HISTORIC AND DESIGN REVIEW COMMISSION

October 16, 2019

HDRC CASE NO: 2019-581
ADDRESS: 134 CALLAGHAN AVE
113 LEIGH ST
LEGAL DESCRIPTION: NCB 719 BLK 1 LOT 8 OR RED 6
ZONING: RM-4, H
CITY COUNCIL DIST.: 1
DISTRICT: Lavaca Historic District
APPLICANT: Evan Morris
OWNER: Leslie Meenan
TYPE OF WORK: Fenestration modifications, roof replacement, site modifications
APPLICATION RECEIVED: September 27, 2019
60-DAY REVIEW: November 26, 2019
CASE MANAGER: Rachel Rettaliata
REQUEST:

Lavaca Remodel

ELEVATIONS -
CALLAGHAN
PROPOSED

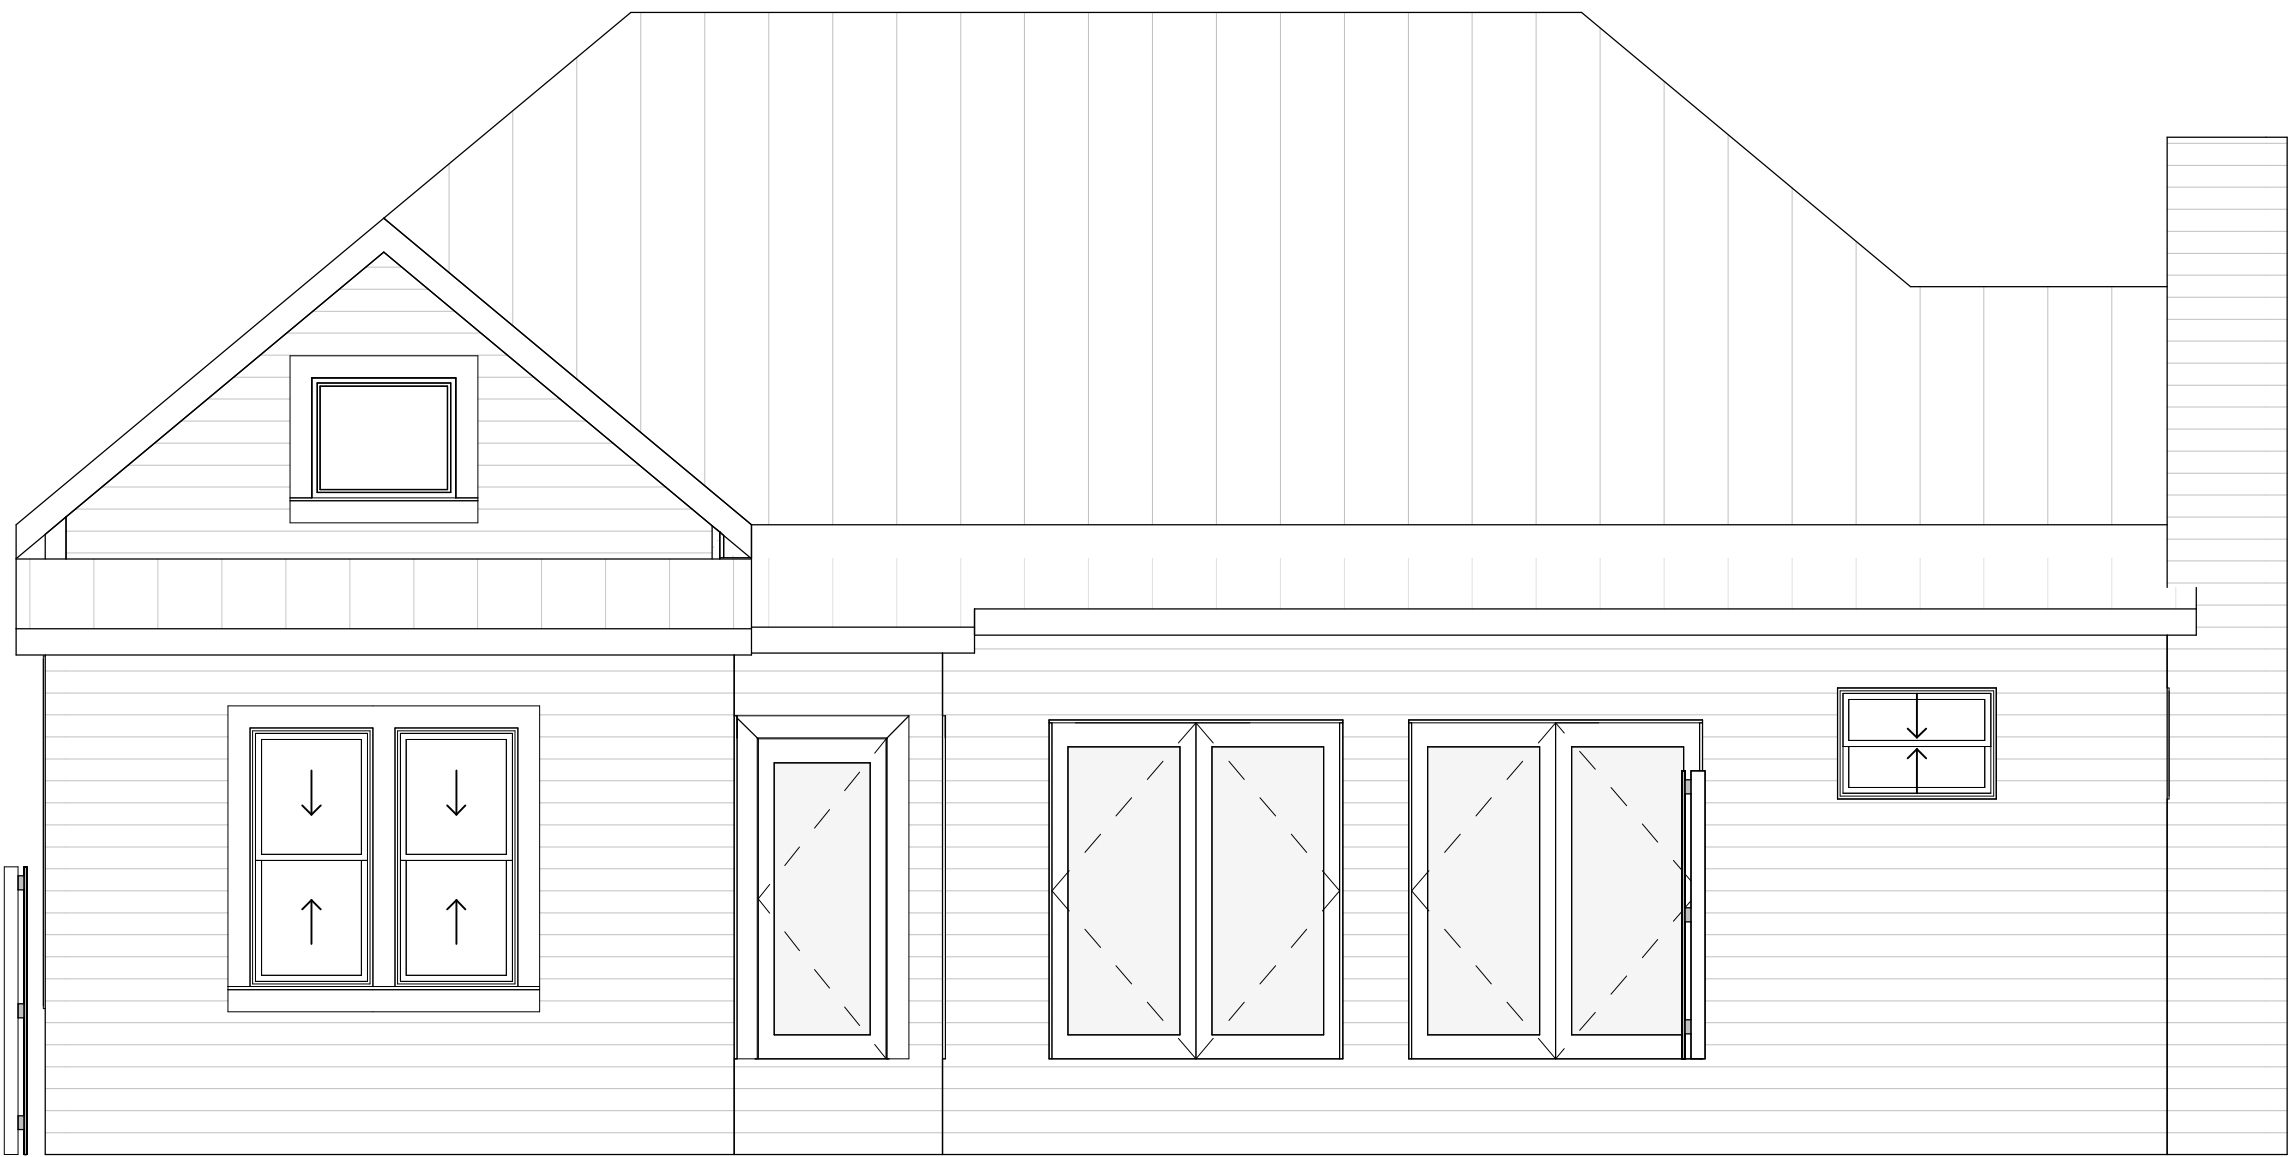
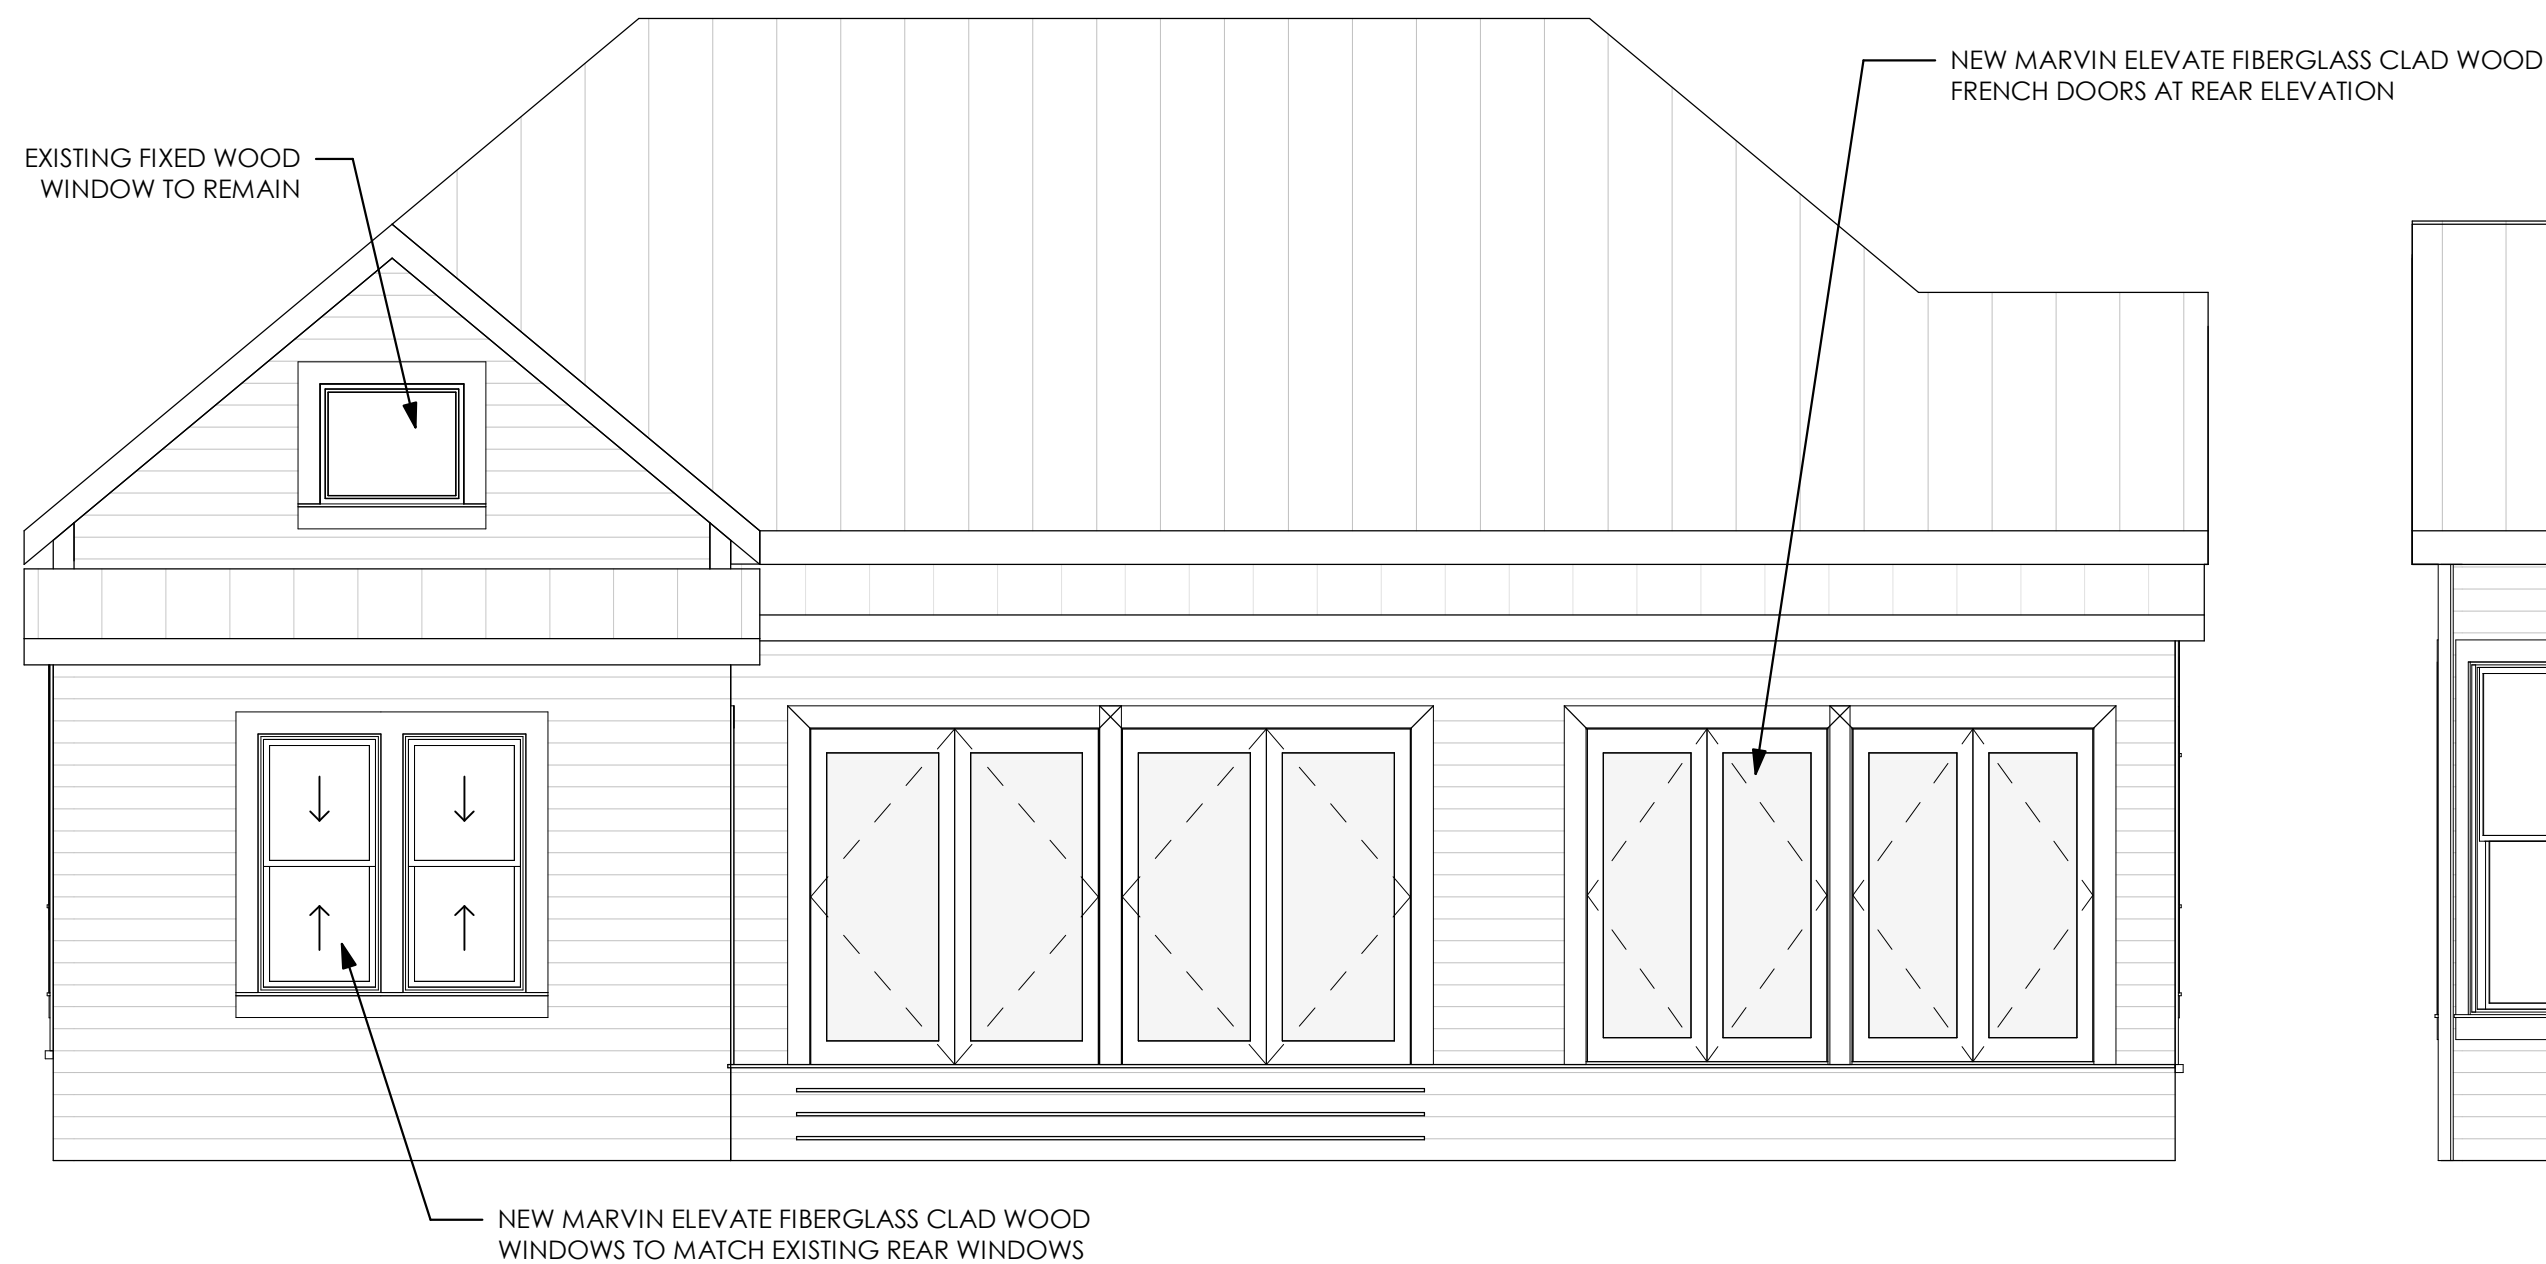
- 1b. PORCH DETAILING – The submitted drawings do not feature the architectural detailing of the existing front porch. No porch modifications are proposed as part of this submittal. Staff clarifies that the architectural detailing of the front porch railing that is absent from the architectural drawing shall not be removed and must be repaired, rather than replaced.

- 1c. FENESTRATION MODIFICATIONS AND WINDOW REPLACEMENT – The applicant has proposed to replace the existing fenestration on the side (east and west) and rear (south) elevations with new Marvin Elevate fiberglass-clad wood double-hung windows and doors and to modify the side (east and west) and rear (south) elevations with new fenestration consisting of new Marvin Elevate fiberglass-clad wood double-hung windows and doors. According to the Guidelines for Exterior Maintenance and Alterations 6.A.iii., and 6.B.iv., in kind replacement of windows is only appropriate when the original windows are beyond repair. The Historic Design Guidelines also state that replacement windows and new windows should match the historic windows in terms of size, type, configuration, material, form, appearance, and detail when original windows are deteriorated beyond repair. The Historic Design Guidelines for Doors state that existing door openings should be preserved and creating new primary entrances on the primary façade or where visible from the public-right-of-way should be avoided. Additionally, the Guidelines state that doors should be replaced in-kind when possible and when deteriorated beyond repair. New entrances, when necessary to comply with other regulations, should be compatible in size, scale, shape, proportion, material, and massing with historic entrances. Staff finds that the applicant has not provided evidence that the original windows and doors are deteriorated beyond repair and the proposal is not consistent with the Guidelines.

- 1d. CHIMNEY REMOVAL – The applicant has proposed to remove an existing, non-original chimney located on the east elevation. The chimney is currently clad with wood siding. Per the 1912 Sanborn Map, this structure originally featured a wraparound porch, and no chimney on the east elevation. Staff finds the removal of the chimney to be appropriate as it is neither original nor contributing to the historic structure.

Item 1a, Staff does not recommend approval of the window replacement based on finding 1c. Staff recommends that the applicant repair the existing wood windows in place.

- i. That the applicant installs one-over-one fully wood windows to match the existing configuration as closely as possible. The proposed aluminum clad replacement product is not appropriate. Meeting rails must be no taller than 1.25” and stiles no wider than 2.25”. There should be a minimum of two inches in depth between the front face of the window trim and the front face of the top window sash. This must be accomplished by recessing the window sufficiently within the opening or with the installation of additional window trim to add thickness. The final specification should be submitted to staff for review prior to the issuance of a Certificate of Appropriateness.

Item 1b, Staff recommends approval of the fenestration modifications based on finding 1c with the following stipulations:

- i. That the applicant repairs all original wood windows in place and that all new windows installed are fully wood windows and doors without cladding. New fenestration must be in keeping with historic size, type, configuration, material, form, appearance, and detail. The fenestration modifications are approved on the east elevation with the stipulation that all original openings remain in the current position. The applicant is required to submit a final window specification for wood windows and doors to staff for review and approval. The windows must meet the following stipulations: meeting rails must be no taller than 1.25” and stiles no wider than 2.25”. There should be a minimum of two inches in depth between the front face of the window trim and the front face of the top window sash. This must be accomplished by recessing the window sufficiently within the opening or with the installation of additional window trim to add thickness. Window trim must feature traditional dimensions and architecturally appropriate sill detail. Window track components must be painted to match the window trim or concealed by a wood window screen set within the opening.

- ii. That the applicant submits updated elevations to staff for review and approval prior to receiving a Certificate of Appropriateness.

Item 1c, Staff recommends approval of the removal of the existing chimney based on finding 1d.
